APPENDIX 9-A REVISED

OPRHP Correspondence

Project: Somersset Solar Project (140-200 MW/? acres)

PR#: 21PR00981

SHEET TITLE & DESCRIPTION:
SITE OVERVIEW

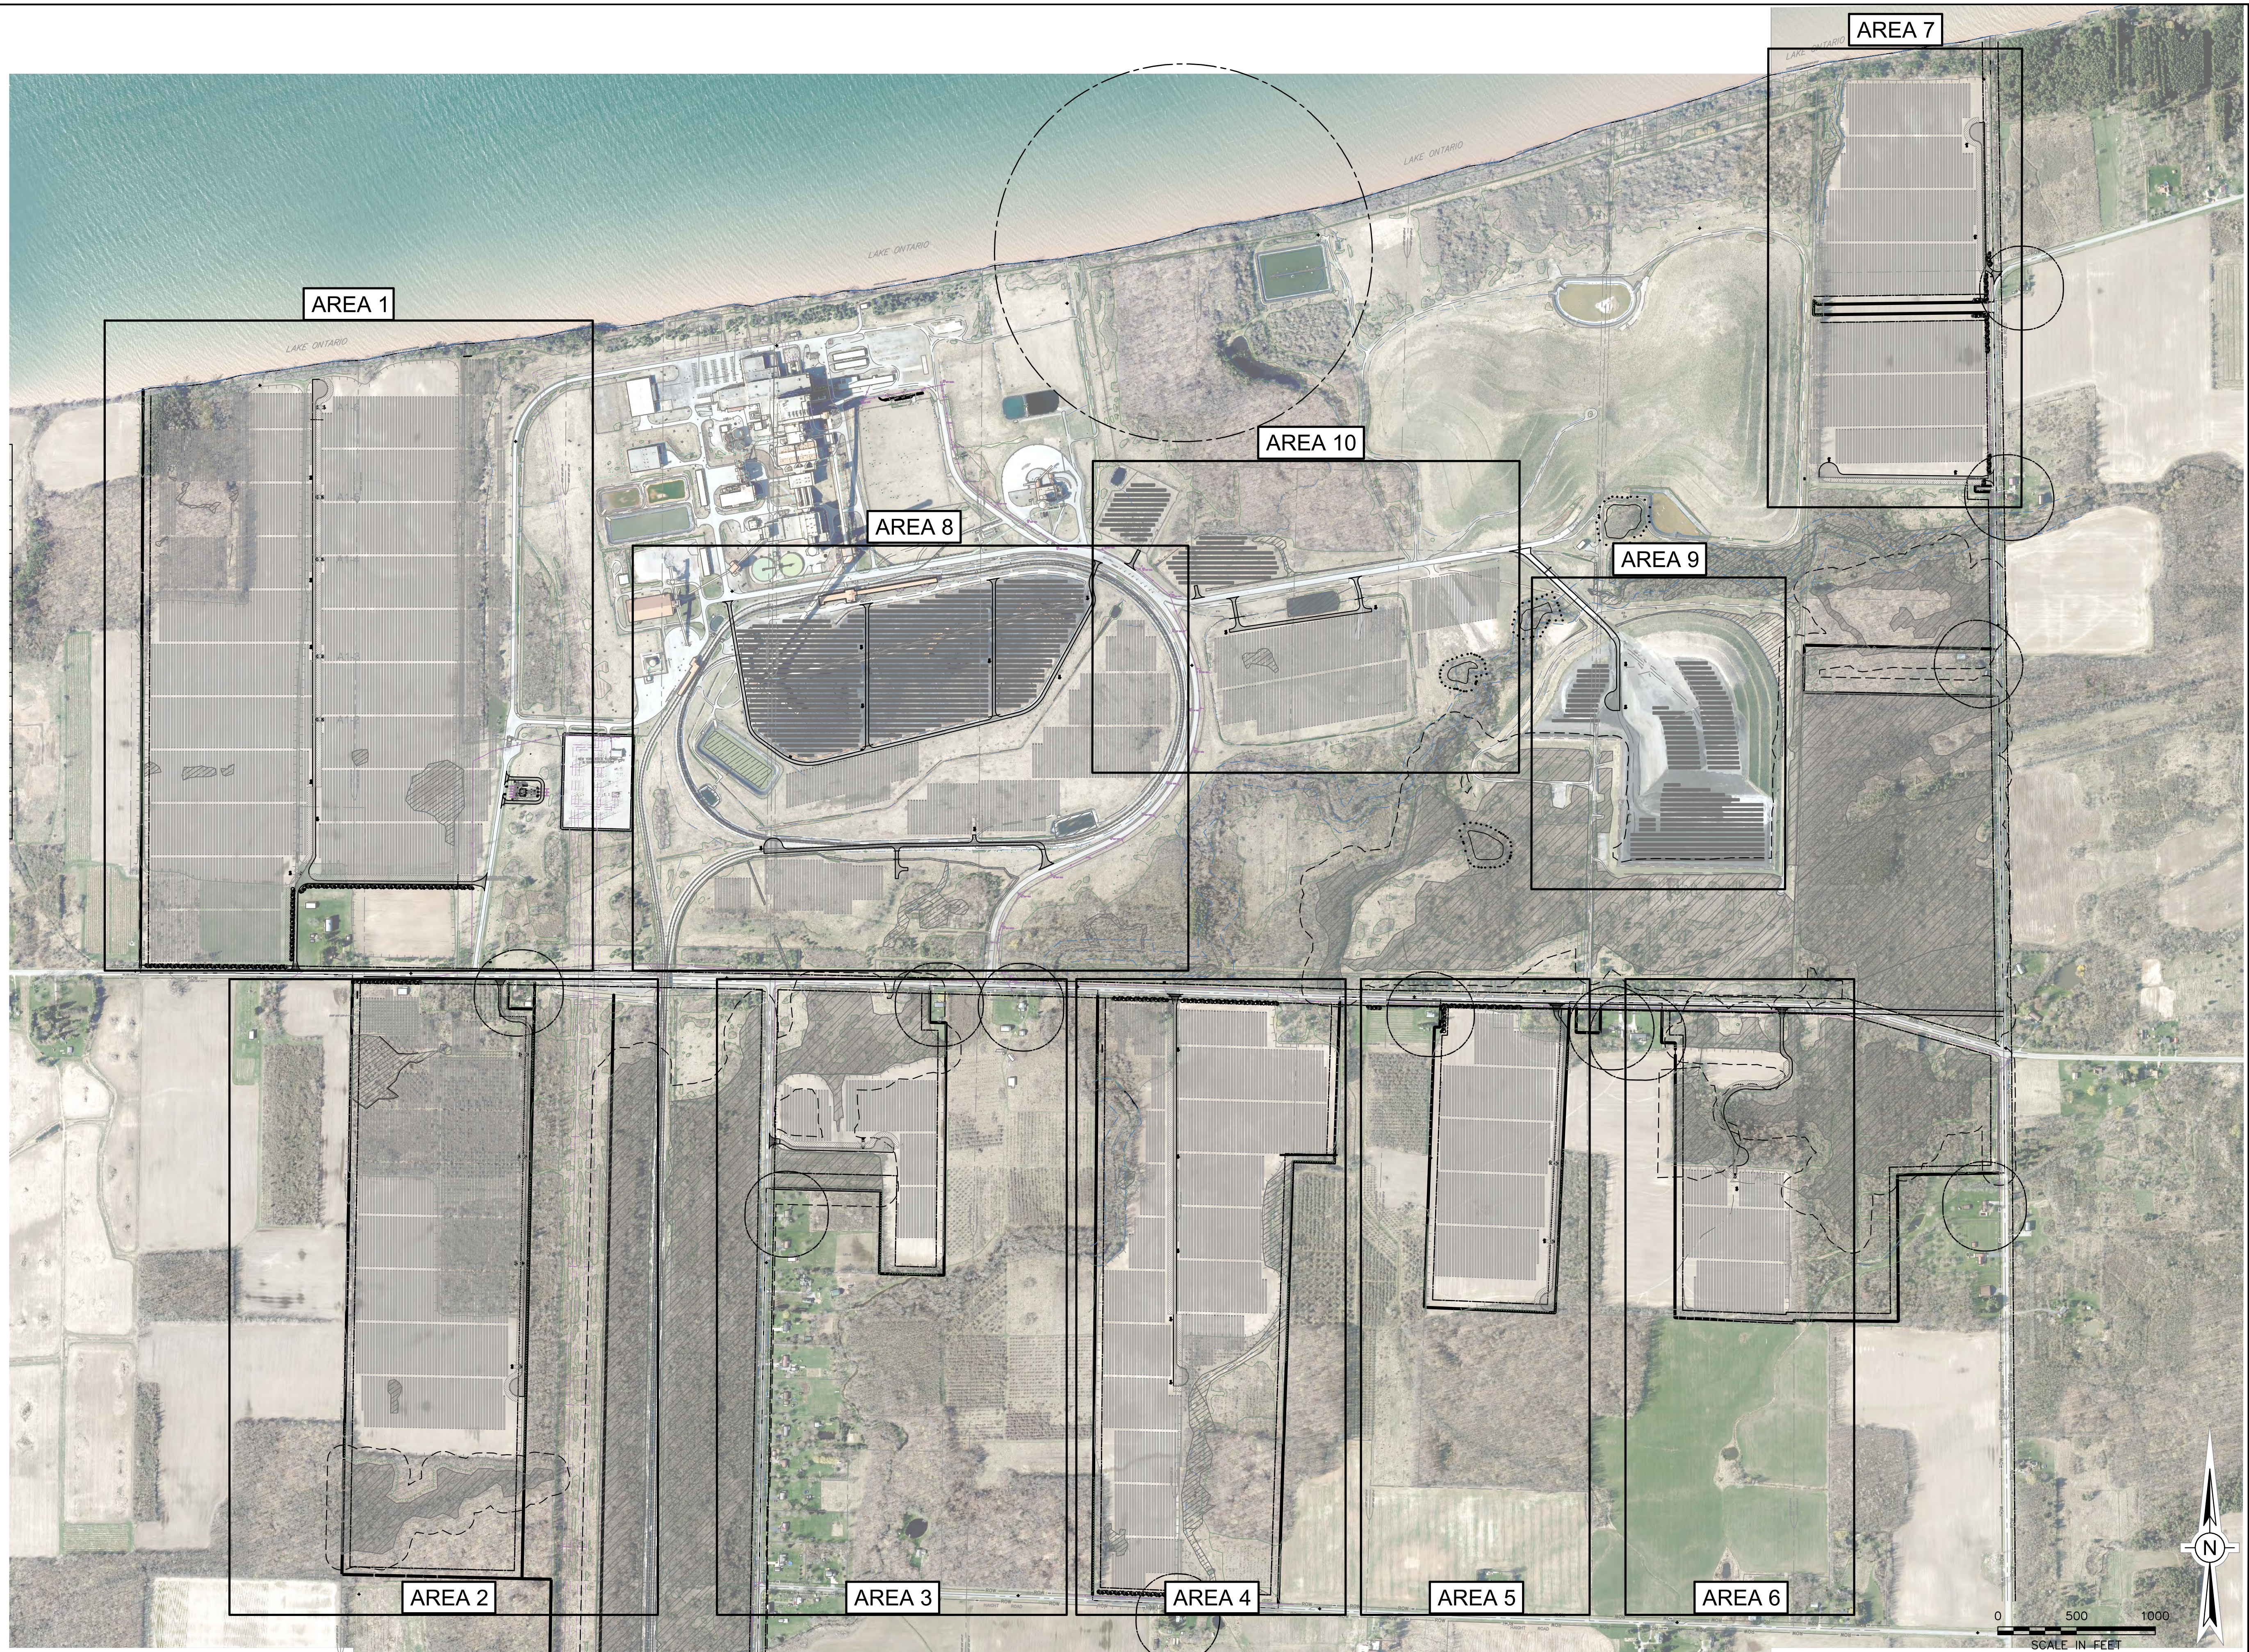
1. Detailed site plans showing solar panels, access roads, and other features, as well as any existing or proposed vegetative or topographic buffers, in the immediate vicinity of the Smith Residence and Babcock House. (It is useful for these plans to be superimposed with satellite or orthographic images.) Please also include, elevation drawings of the solar panels indicating maximum panel height and direction of rotation.

Response: The requested site plans (superimposed over aerial imagery) and elevation drawings are included in Attachment A, and include a site plan overview (PV-C.02.00), site plans for the Facility areas in the vicinity of Smith Residence (PV-C.02.01) and Babcock House (PV-C.02.02), and Conduit Management Standards (1 of 3 and 2 of 3) (PV-E.05.11 and PV-E.05.12). Both fixed tilt and single-axis panels are proposed, with fixed tilt panels having a maximum height of 7.14 feet from grade, and single-axis panels having a maximum height of 10.24 feet (maximum) from grade. The single-axis panels will be

oriented north-south and rotate along this north-south axis to track the sun's direction from east to west throughout the day. Attachment A also includes a landscape plan that depicts the proposed vegetation screening that will reduce anticipated visual impacts to the Babcock House, which is located on a participating property of the Facility. As noted below in response to Item #3 and documented in Attachments B and C, visual screening for the Smith Residence is not proposed, as this location is not anticipated to have views of the Facility. However, screening along the southern end of the photovoltaic array located on Lake Road, is included in the visual screening plan for the Facility.
